**RESIDENTIAL FLAT BUILDING DEVELOPMENT
80 – 82 SHOWGROUND ROAD GOSFORD 2250**

**BUILDING CODE OF AUSTRALIA 2022
CONCEPT DESIGN REPORT
FEBRUARY 2025**

Report reference 23200R03

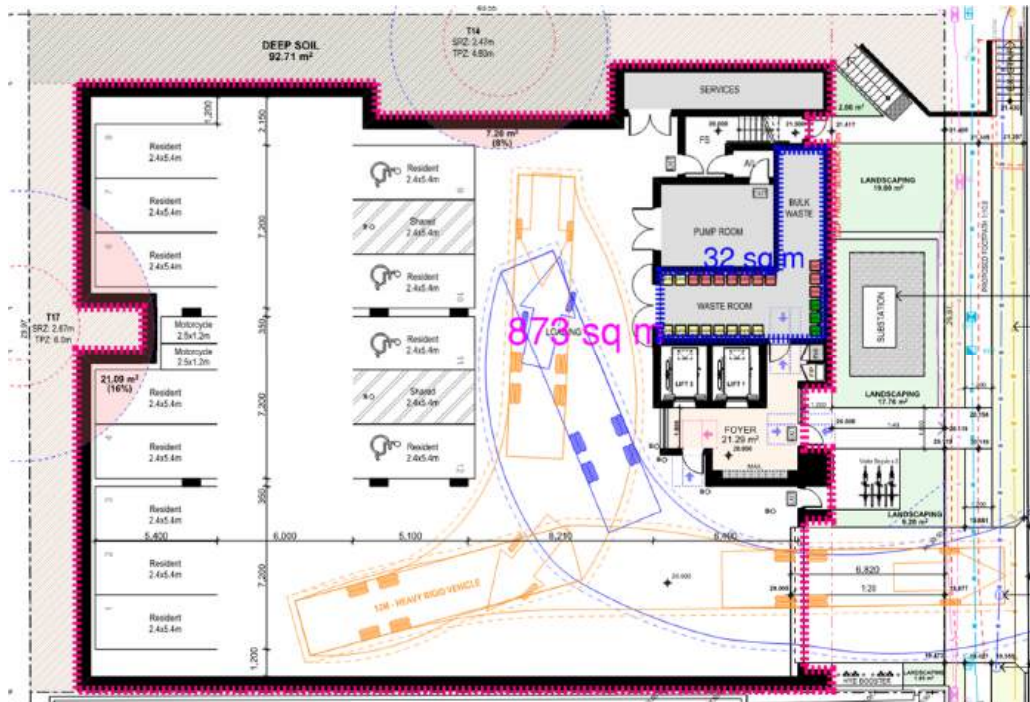
The waste storage area shown on the basement level measures approximately 32 m². This is less than 10% of the floor area of the basement, and therefore does not attract a 7b storage classification.

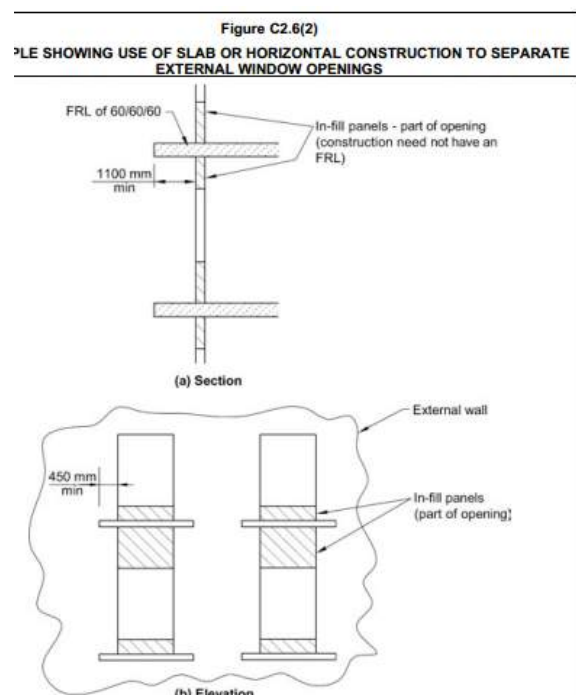
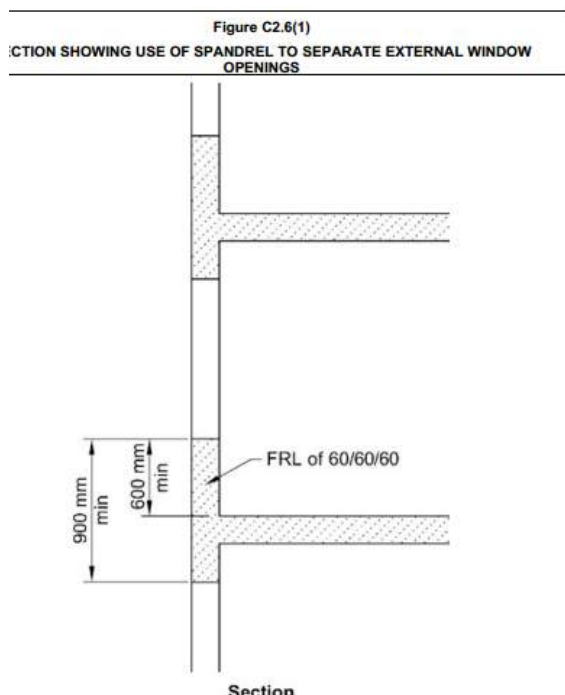
In the detail design documents, provide confirmation/tested system details stating that the southern elevation wall cladding MC2, and any support structure, achieves the required spandrel FRL of 60/60/60. Confirm that the openings protected by a horizontal spandrel are set back a minimum distance of 450mm and that they have a minimum depth of 1100mm.

The MC2 sections of the external wall are also required to be non combustile in addition to complying with the BCA weatherproofing requirements.

Provide confirmation that all masonry spandrels achieve the same required 60/60/60 FRL.

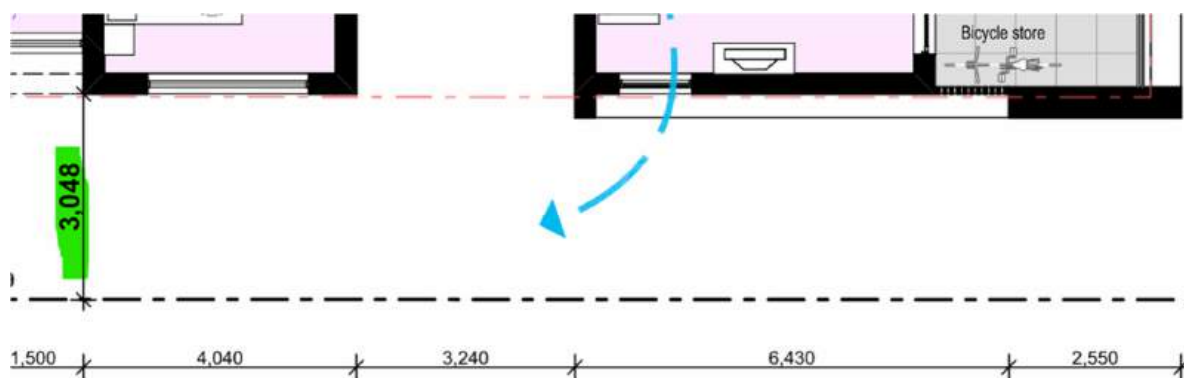
Any openings within the below southern external wall are required to be protected in accordance with BCA Specification 12 (see clause below) if the distance from the wall to the boundary is less than 3m.

Metro notes that a construction tolerance has been added to the Southern external wall, to keep the openings in that wall 3m or more from southern boundary, which is a fire source feature.

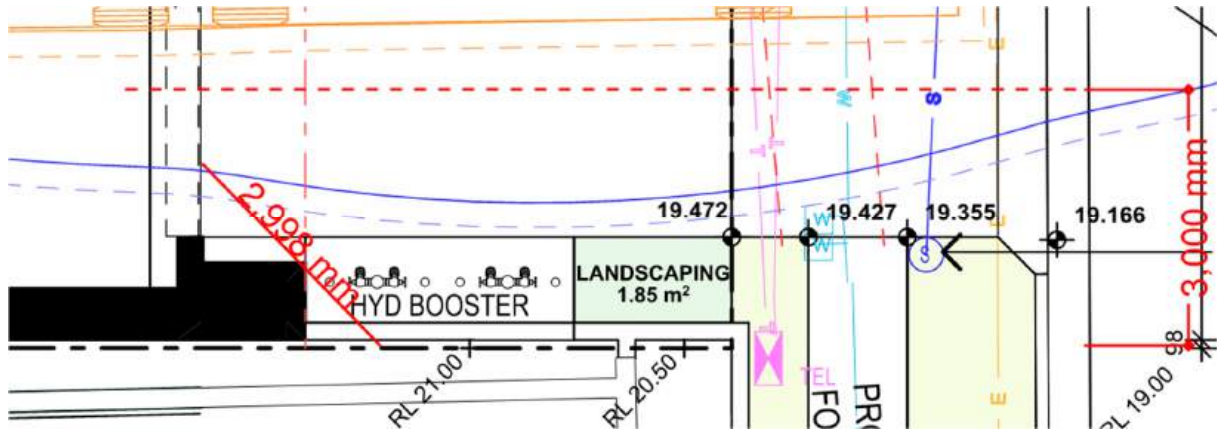
The carpark opening is shown to be within 3m of the boundary, but the opening is being shielded by a 'blade' section of masonry that is in addition to the external wall of the 7a carpark.

Confirm that the thickness of masonry that is shielding the opening from the boundary is adequate to provide the required 30/-/ shielding.

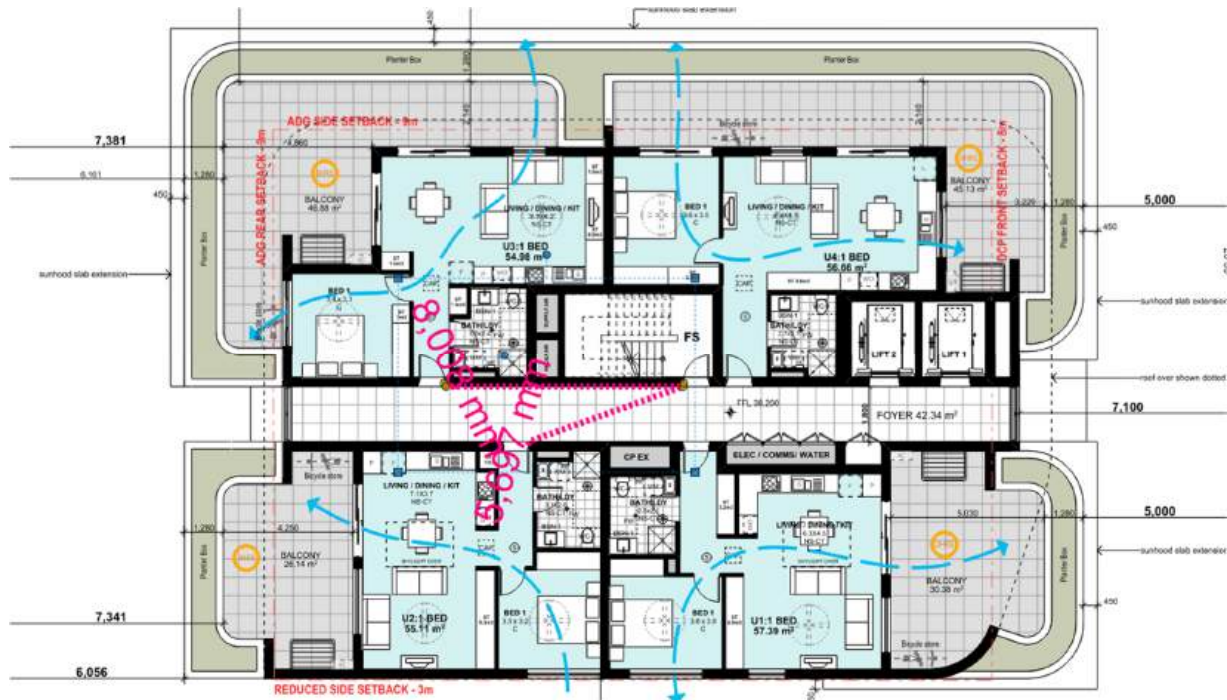
On the Level 01, units 1, 4, & 5 exceed the 6m travel distance to a required exit, an will need the Specification 18, 12m travel sprinkler concession for compliance, or a fire engineered performance solution.

On the Level 02, units 1, 4, & 5 exceed the 6m travel distance to a required exit, and will need the Specification 18, 12m travel sprinkler concession for compliance, or a fire engineered performance solution.

On the Level 03, units 1, 4, & 5 exceed the 6m travel distance to a required exit, and will need the Specification 18, 12m travel sprinkler concession for compliance, or a fire engineered performance solution.

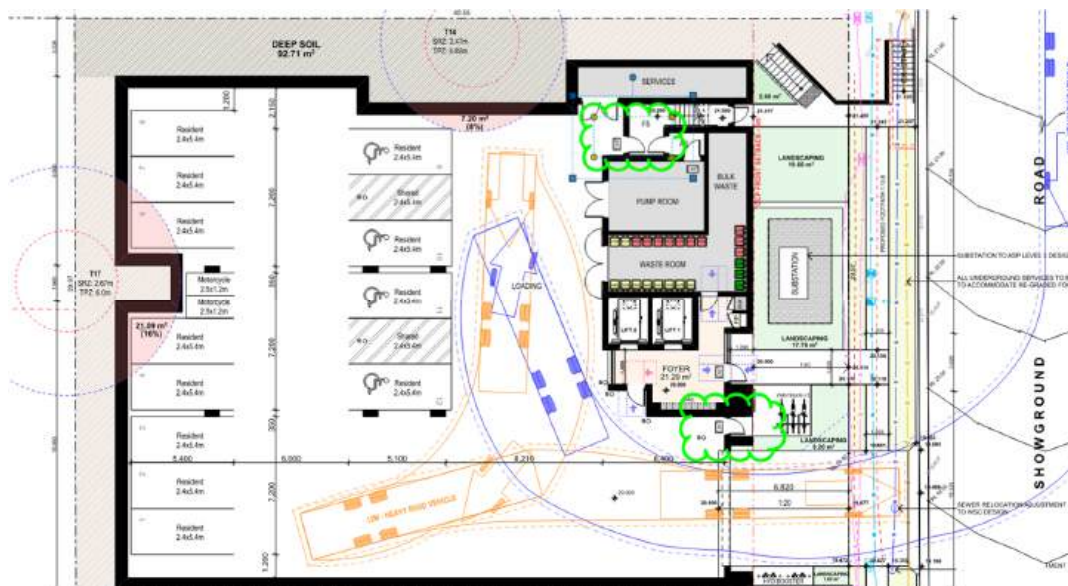
The location of the alternative required exits from the basement are not distributed as uniformly as practicable within or around the storey served, as they are all located on the Eastern side of the building. The current design may be considered under a fire engineered performance solution.

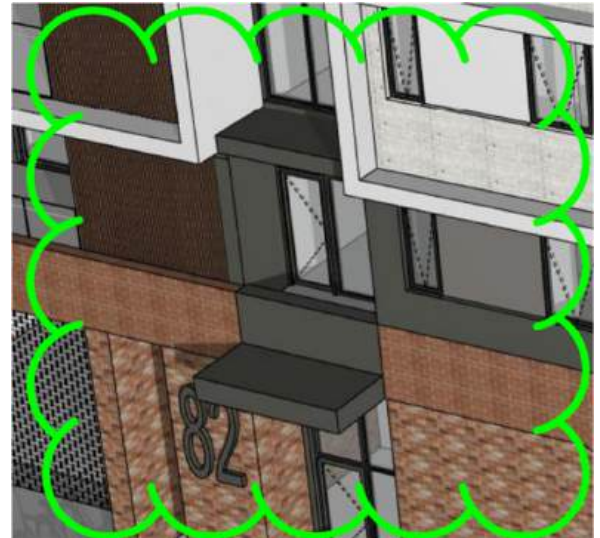
The Juliet style balcony on the Ground level Eastern street frontage is a common area, and requires access to it.

- An 850mm clear doorway opening
- A minimum 1540mm x 2070 space to turn around in, in addition to the circulation space at the door.

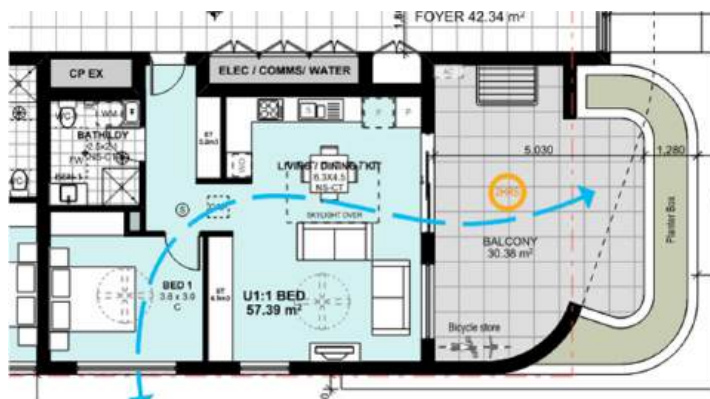
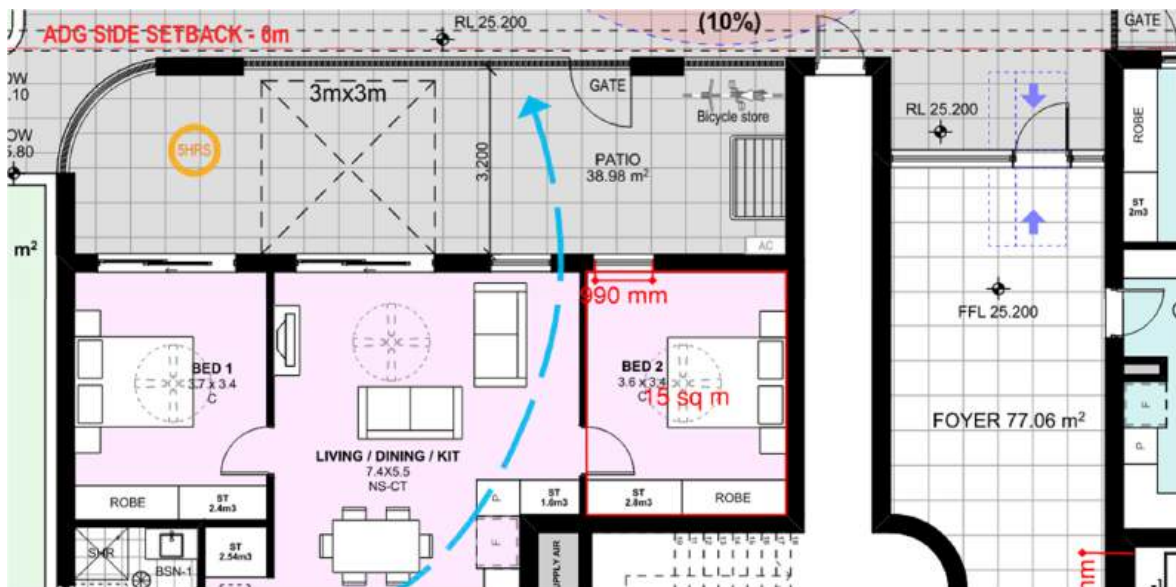
Metro is concerned that the window serving Bed 2 in Unit 4 on the ground floor does not meet these requirements, due to:
